5 February 2008

RESPONSE TO PART 3A APPLICATION COMMENTS – DOLPHIN POINT STAGES 2 & 3

Figure 2-1 Differences in Key Ocean Levels – 2090-2100 (IPCC 2007 + CSIRO McInnes et al

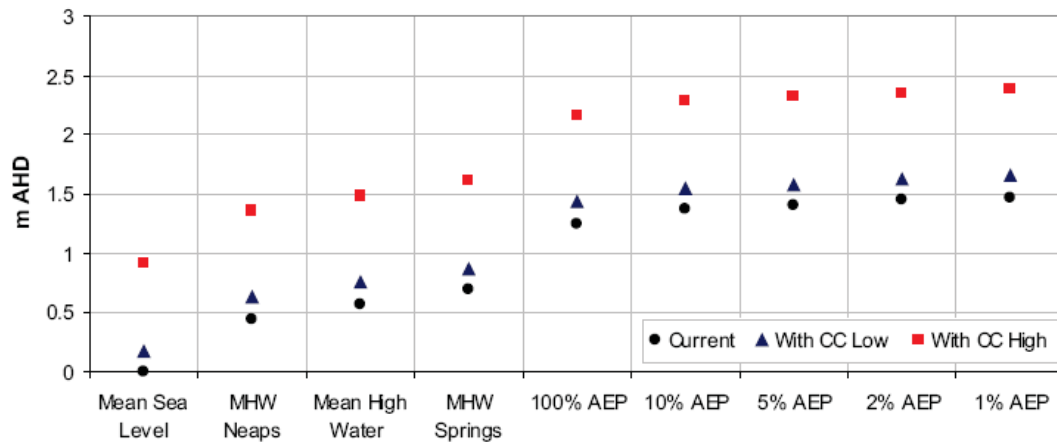
Figure 2.1, taken from PCCC, shows a comparison of sea level for the current, and low and high impact scenarios for different tidal and storm event conditions.

The sea level rise would not affect the tailwater condition of Creek 1, as the permanent water level in the water quality control pond at RL3.0m is above the sea level condition of a 1% AEP event with the high climate change sea level rise scenario. The tailwater condition of Creek 2 has also been elevated to RL 3.0m AHD and likewise, would not be affected by the sea level rise scenarios in the PCCC.

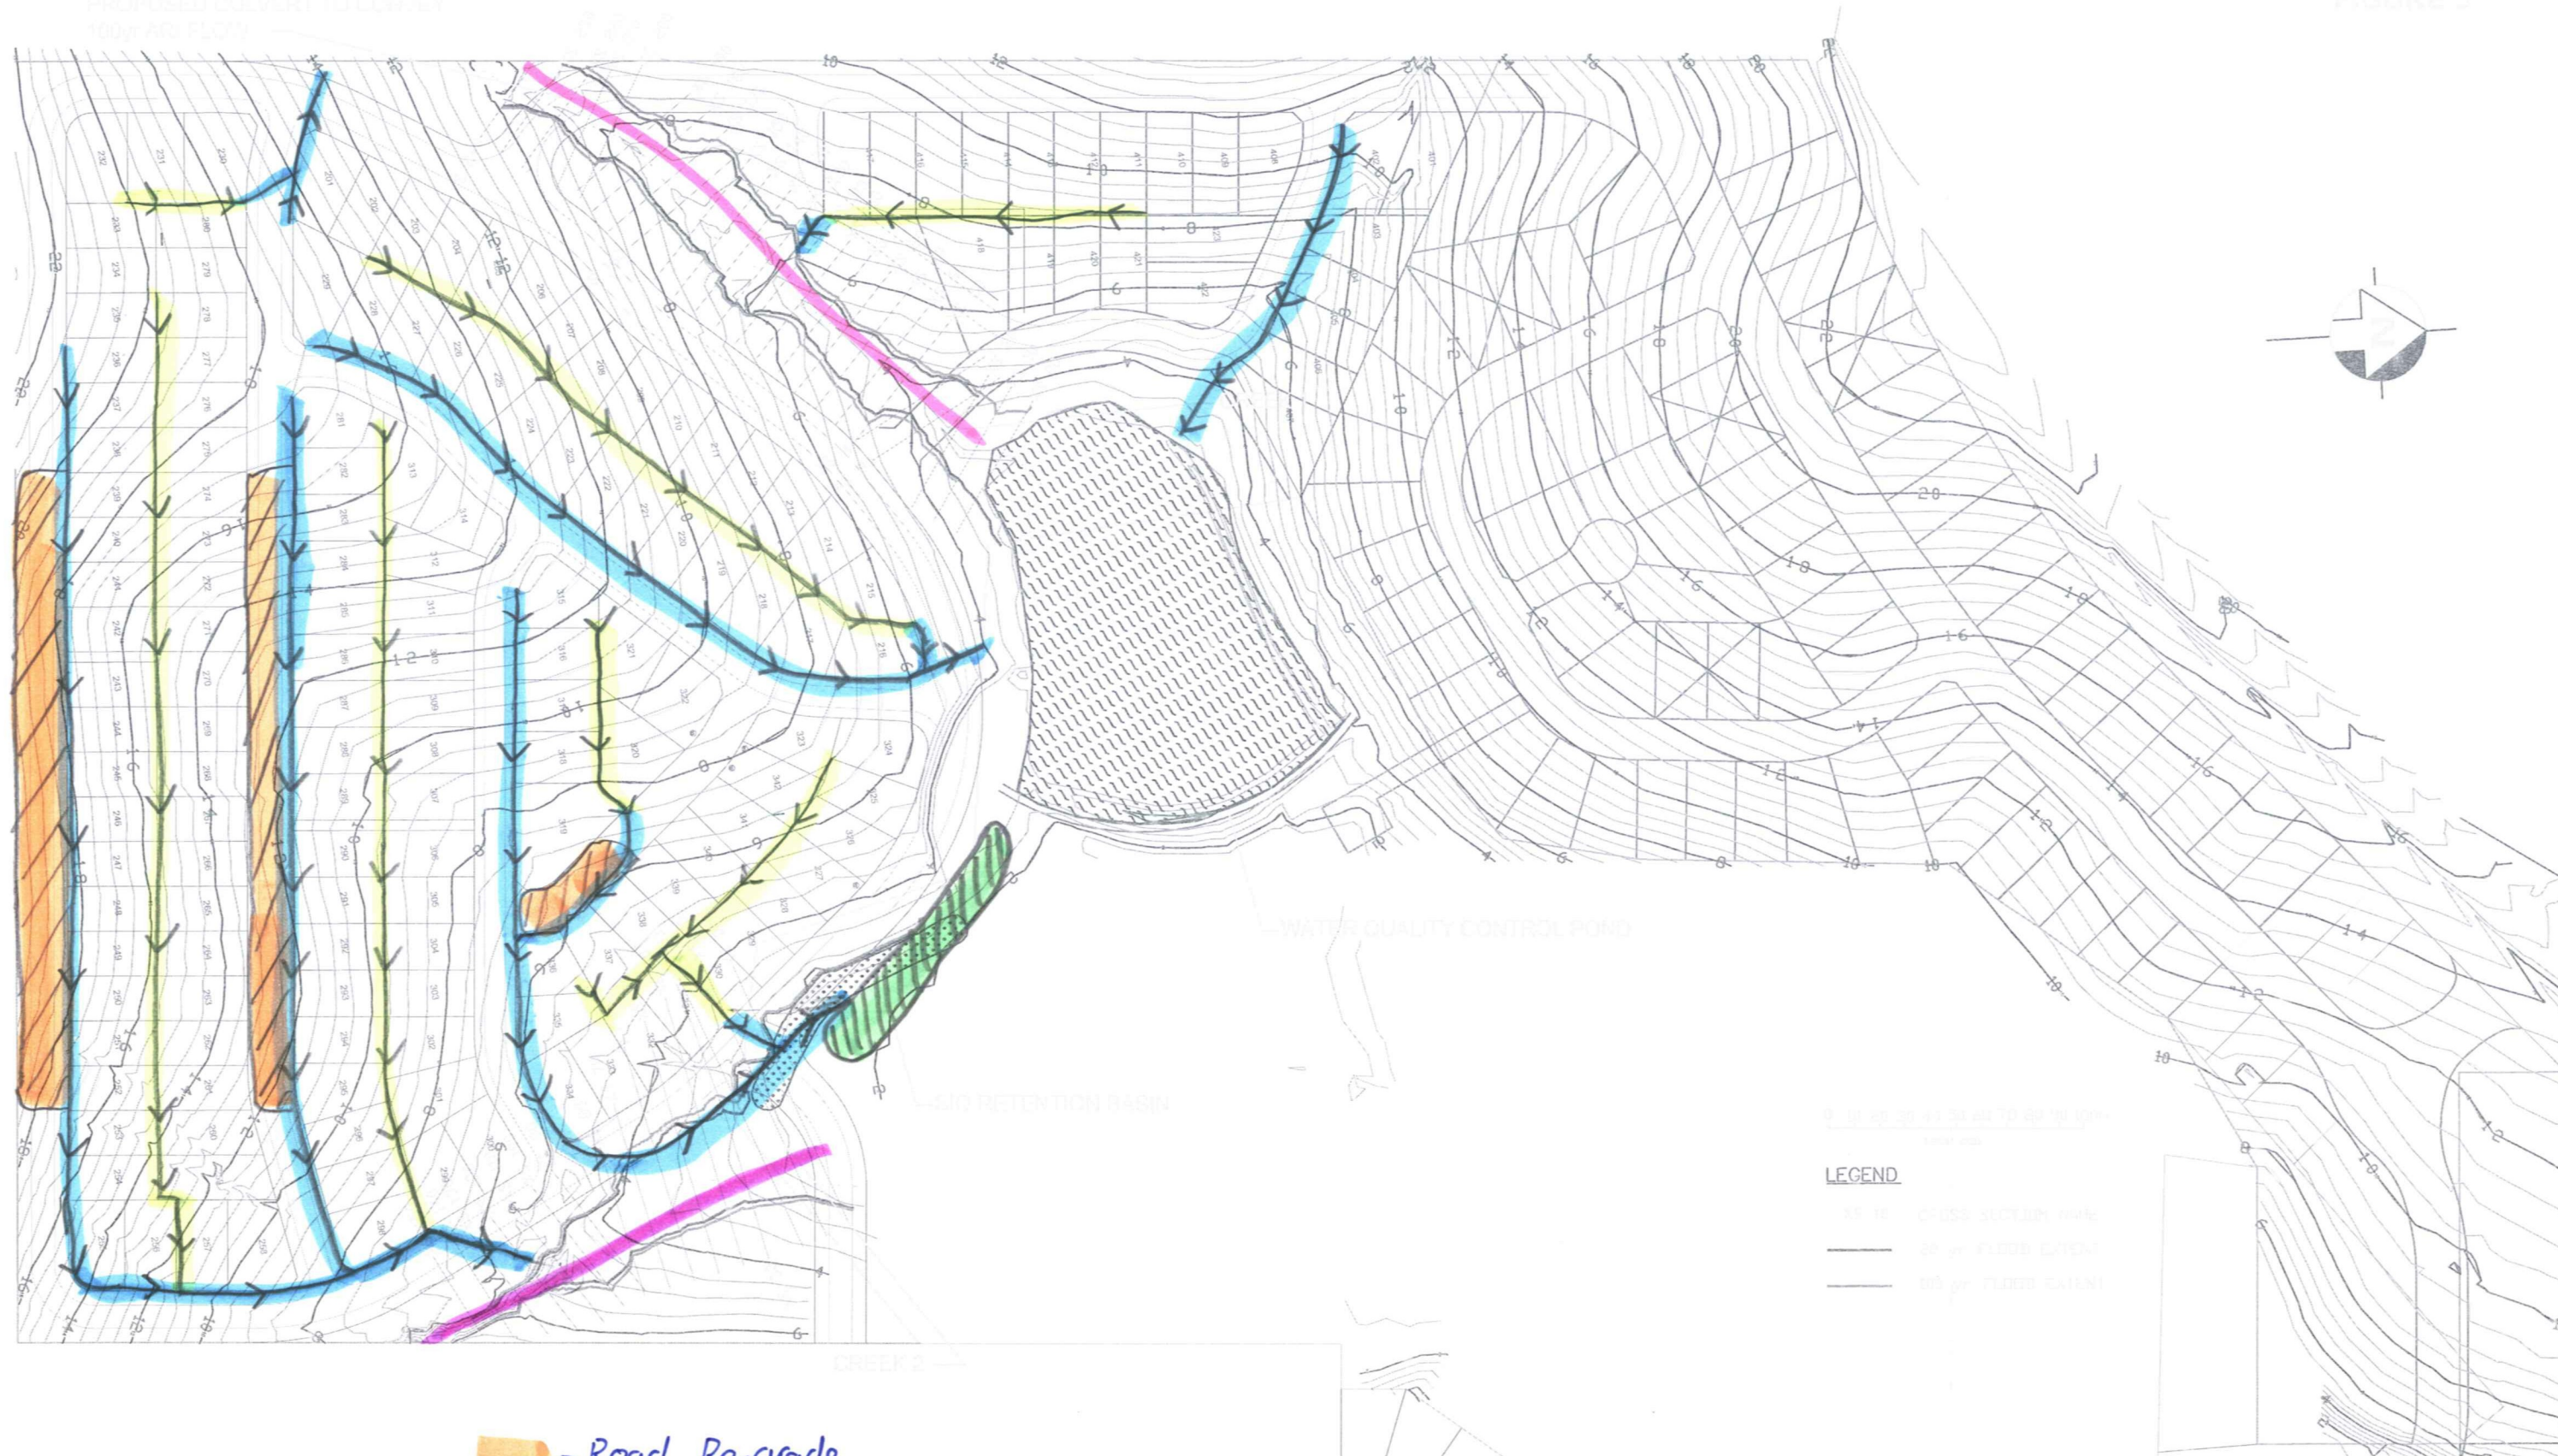
Given that the road and lot layout has changed, the location of the stormwater infrastructure will need to be altered accordingly. Roads will also need to be graded to ensure that flows are able to drain overland from the site. A sketch is provided attached, showing the revised stormwater management plan.

In the case of inlet blockage or an extreme event, overland flows from OL 1 would travel via the roadway at the northern side of Stage 3 to the WQCP and on to Burrill Lake. OL 2 would flow overland to the east along Road no. 8 (reggraded to remove a trapped low point) and then down Road no. 3 to Creek 2.
